UNITED STATES
DEPARTMENT OF THE INTERIOR
BUREAU OF LAND MANAGEMENT

SUNDRY NOTICES AND REPORTS ON WELLS
Do not use this form for proposals to drill or to re-enter an abandoned well Use Form 3160-3 (APD) for such proposals
SUBMIT IN TRIPLICATE - Other instructions on reverse side.

APACHE EBDU #105

INTERIM RECLAMATION LAYOUT EBDU #105

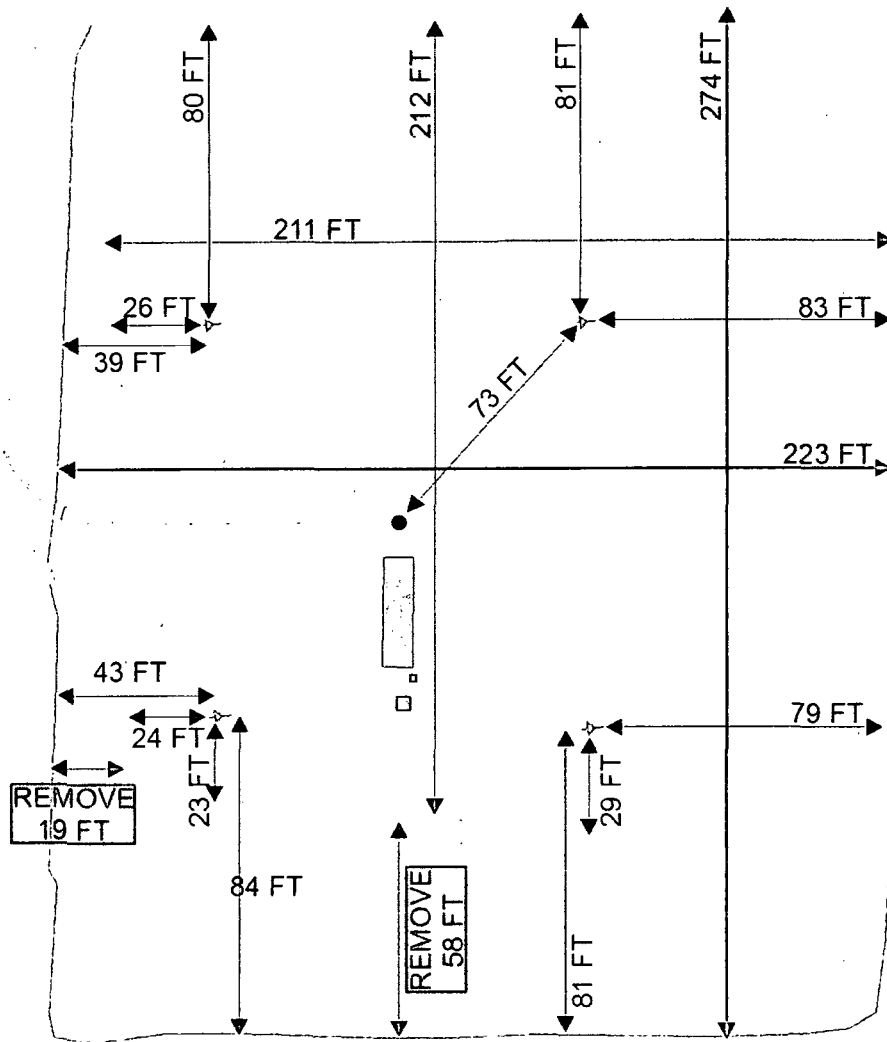
Location size: 274x223, APD drawing 270x235, after downsize 211x212 not 175x150

Downsize as per APD: 95' north and 85' east

On the north side of the pad we could not downsize the 85' plus this was the frontage of the unit and on the east side we could not downsize the 85' due to entrance of location.

The actual anchor measurements on the north are 80-81' from the edge and 79-83' on the east anchors. Therefore Apache Corporation took 81-84' off of the south edge and 19' from the west edge. This location has some erosion issues that can be corrected.

Due to actual measurements, placement of anchors and wellbore the APD requirements could not be met.

The former pad measured 274 FT x 223 FT.

The downsized pad measures 212 FT x 211 FT.
